STREET A PLAN AND
PROFILE

PARKER RIDGE
82 SCHOOL STREET
ROLESVILLE / NORTH CAROLINA / 27571

08/01/2023 PER TOWN OF ROLESVILLE COMMENT

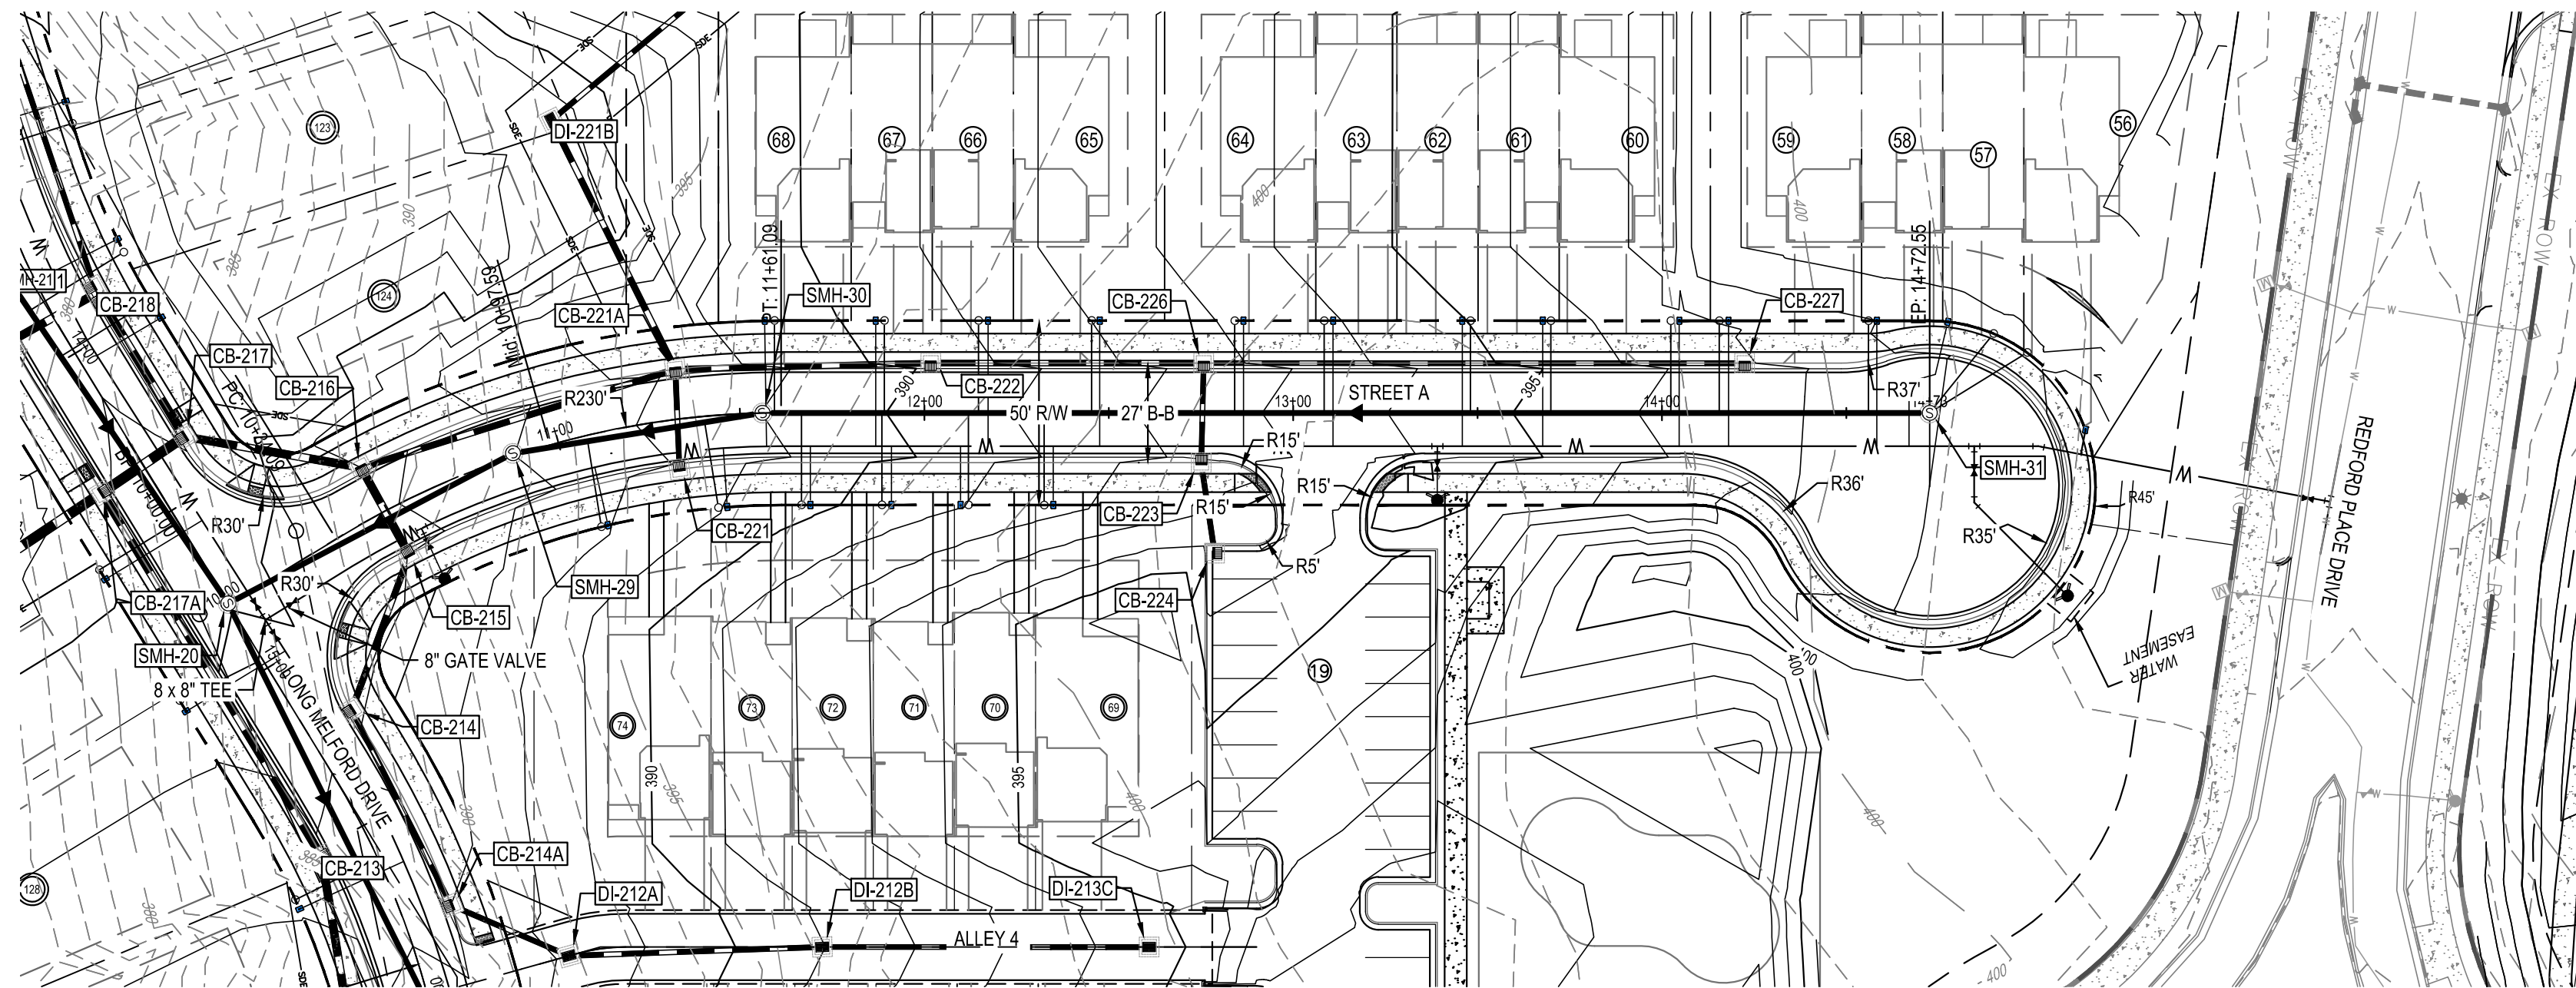
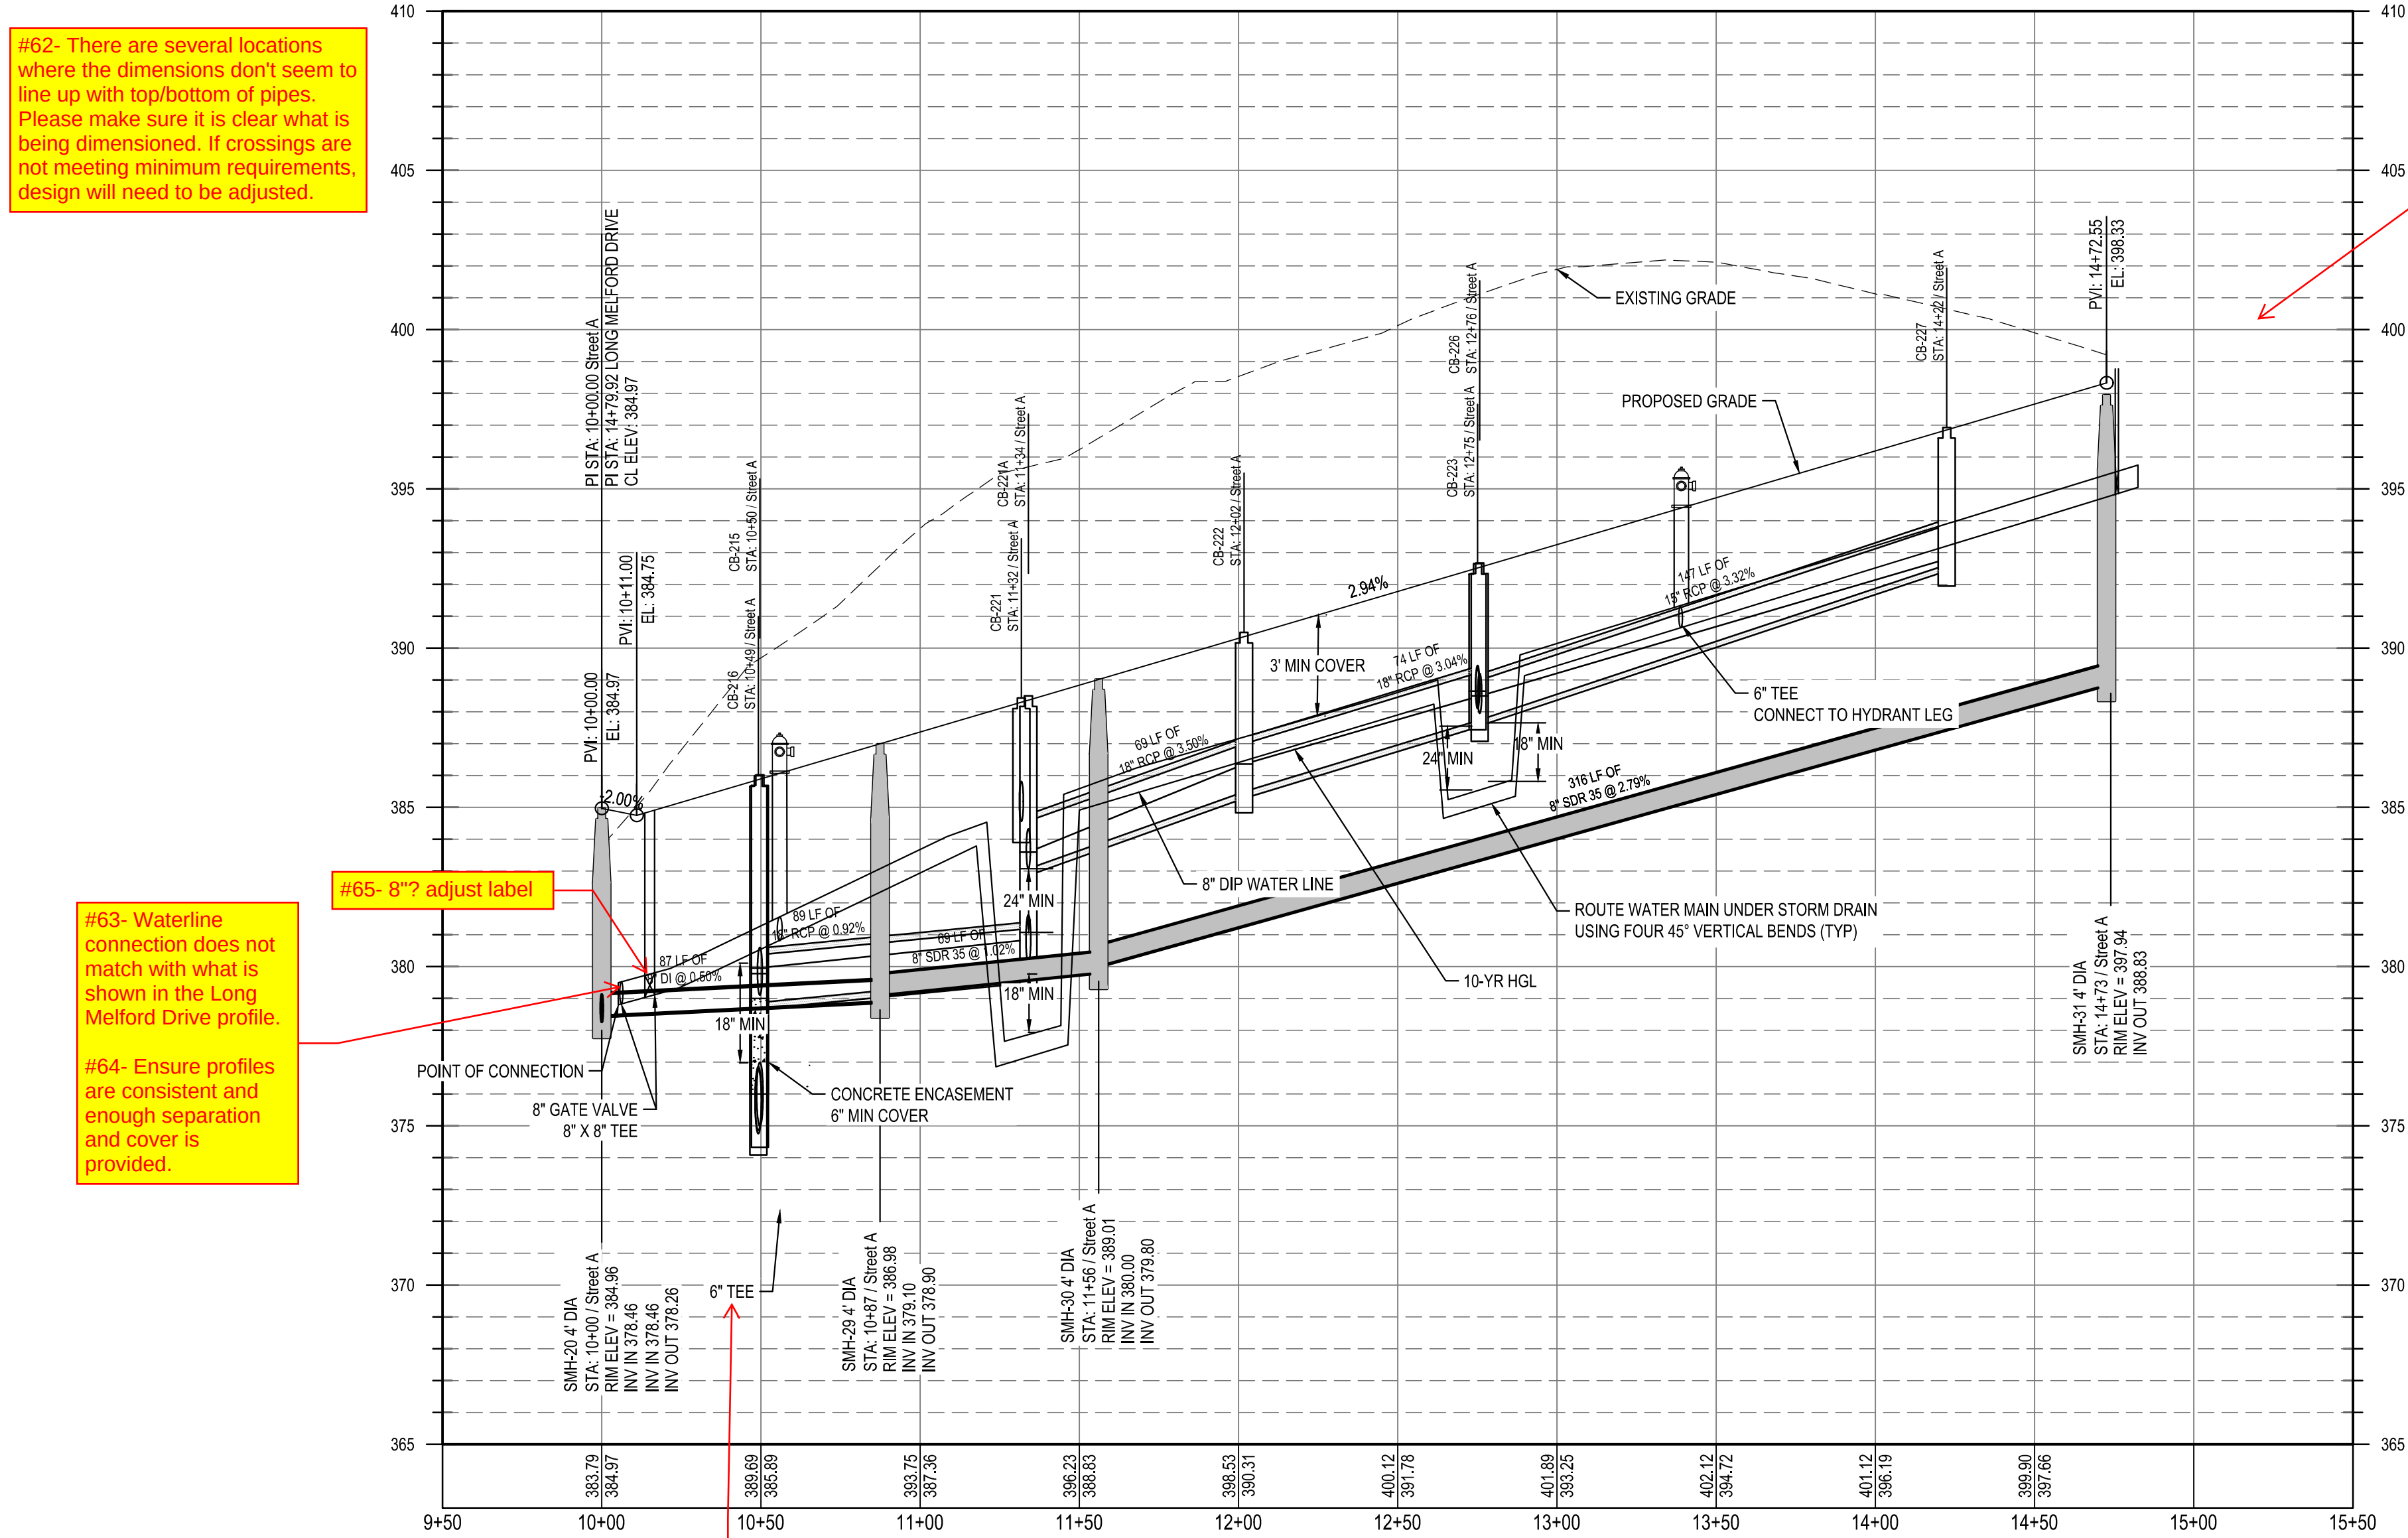
#62- There are several locations where the dimensions don't seem to line up with top/bottom of pipes. Please make sure it is clear what is being dimensioned. If crossings are not meeting minimum requirements, design will need to be adjusted.

#63- Waterline connection does not match with what is shown in the Long Melford Drive profile.

#64- Ensure profiles are consistent and enough separation and cover is provided.

#65- 8" adjust label

#4- Not pointing to anything

#66- Continue profile to include waterline connection into existing Redford Place Drive waterline
